For Board of Architectural Review Meeting of September 2, 2020

Subject: [EXTERNAL]Comment for Sept. 2 BAR Meeting - Heritage Project

Subject: [EXTERNAL] Resending comments on BAR #2020-00197 OHAD

This letter is regarding Docket item #5--BAR #2020-00197 OHAD and Docket item #6- BAR #2020-00196. Unfortunately, my letter today is not as complete as I would have liked due to time constraints resulting from the City of Alexandria BAR Docket computer link to the city staff report (BAR #2020-00197 Staff Report (B)) not being accessible to citizens/public until the afternoon of Monday, August 31, 2020 (despite many people attempting to get assistance for this problem) and the inability to adequately review all associated documents in the short time frame subsequent. Therefore, I ask for a DEFERRAL of this hearing on the grounds that the City of Alexandria has not followed its' own regulations as follows: Per the May 1993 Design Guidelines for the Old and Historic Alexandria District and Parker-Gray District, page 3 of the Design Guidelines states: "Staff reports are made available to the applicant and the general public on the Friday before the Wednesday hearing.". This can only be inte

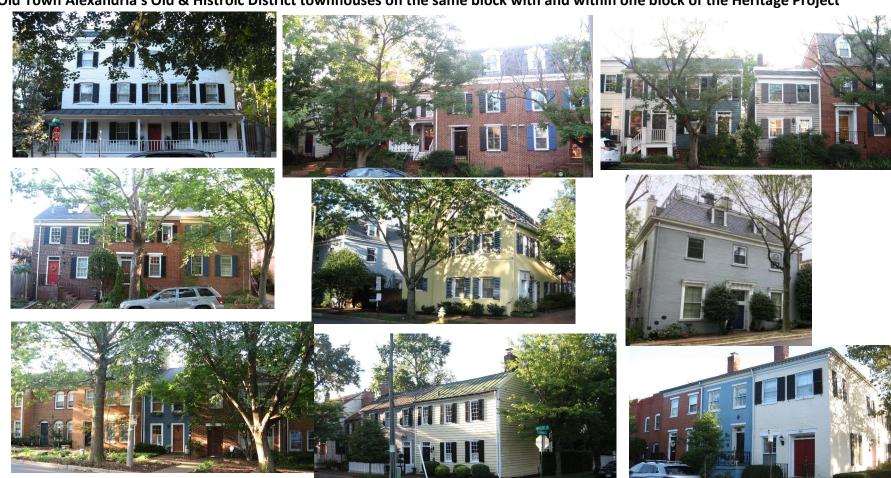
A. The proposed buildings don't make the "Welcome to Old Town" stated goals by city staff in the Community meetings and written plans. Sadly, they very loudly scream: "Welcome to Ballston or Rockville", or worse, National Harbor. As a matter of fact, the architect for this project has pictured on their website the exact same building design as they used for completed projects in Ballston & Rockville (see attached photos). Did they cut and paste—putting no time or effort into this design, just reproducing a cookie cutter behemoth that is passed from architectural firm to architectural firm; jurisdiction to jurisdiction? They look like every other generic, "modern" style building (I use the term "modern" loosely as these are not modern in an artistic sense but merely modern in age; derivative and uninspiring otherwise—buildings such as The Sunrise on S. Washington St. are a good example of architecture that would be appropriate in this area). It just feels as if they didn't even try. Is this because the architects and the developer think so little of our special little town and the surrounding historic homes (and contrary to M. Puskar's repeated claims that there are only townhouses from the 1970's & 1980's along with her teams' submitted maps that, for some reason, do not show these historic homes, there are many historic buildings in the immediate area of this project as well as throughout the South West Quadrant, that date back to the 1800's and even 1700's) that we live in?

Proposed for S. Patrick Street in Old Town Alexandria's Old & Historic District

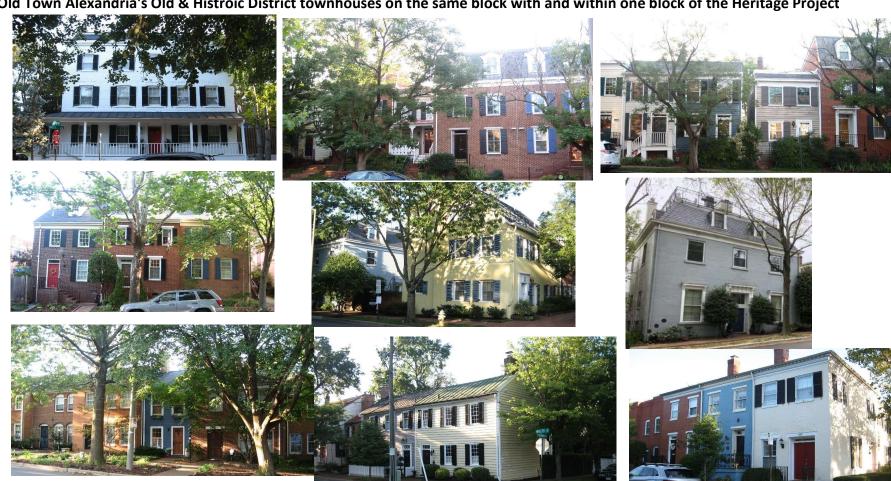
The applicants buildings designed for Old Town Alexandria's Old & Historic District are already in use in Ballston & Rockville. The neighbors have stated numerous times that these buildings do not reflect the Old & Historic District, are not compatiable with the Old & Historic District, and the building guidelines have not been followed therefore the applicants proposed building designs must be changed. The entrance to Old Town's Old & Historic District should not look like Ballton or Rockville.

Vashington Street Elevation

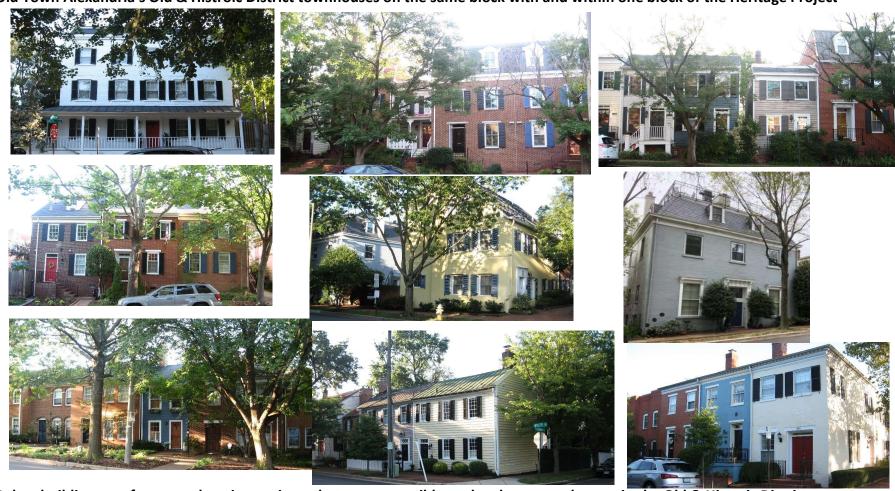
Below buildings are from new housing projects that <u>are</u> compatible to the above townhouses in the Old & Historic District
